UNITED STATES PATENT AND TRADEMARK OFFICE

10/769,741

Office Action Summary	Application No. 10/769,741	Applicant(s) LAKIN ET AL.	
	Examiner Ralph A. Lewis	Art Unit 3732

- 1) ☒ Responsive to communication(s) filed on 29 September 2009.
- 2a) ☒ This action is **FINAL**. 2b) ☐ This action is non-final.
- 3) ☐ Since this application is in condition for allowance except for formal matters, prosecution as to the merits is closed in accordance with the practice under *Ex parte Quayle*, 1935 C.D. 11, 453 O.G. 213.

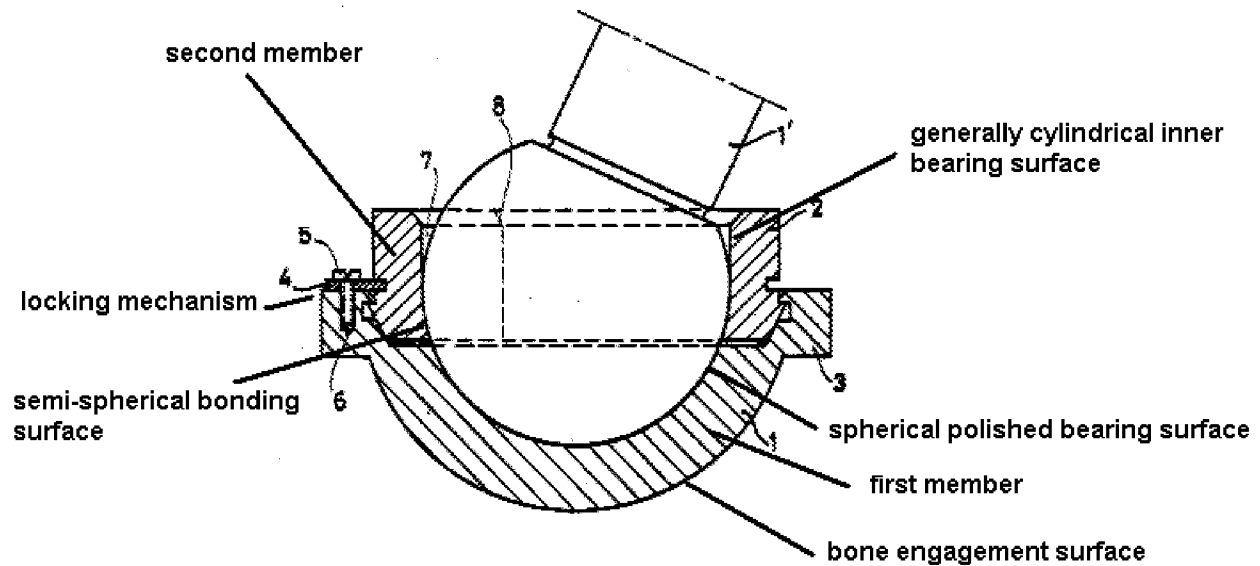
Mullers in Figure 1 reproduced below discloses an acetabular implant having a first member 1 having an outer bone engagement surface and an integral inner spherical polished bearing surface for interfacing with the ball of femoral implant 1'. The first member includes a locking mechanism 4. Mullers further discloses a second member 2 coupled to the first member which defines a partial spherical bearing surface adjacent the spherical surface of first member 1 and a cylindrical bearing surface that allows for gap 7. The Mullers first and second members allow for rotational and

translational movement of the femoral implant 1'. In regard to claim 46 note alignment notches column 5, lines 20-25.

Claims 34-37 and 46 are rejected under 35 U.S.C. 103(a) as being unpatentable over Mullers (US 5,133,763).

In regard to claim 34, to the limited extent that Muller does not explicitly state that the inner spherical bearing surface is polished, then one of ordinary skill in the art would have readily recognized such a surface to be polished in order to reduce wear. In

regard to claim 37, Mullers does not give specific dimensions for the length of the illustrated cylindrical bearing surface, however, one of ordinary skill in the art would have found the selection of a length within the range claimed obvious as a matter of routine practice.
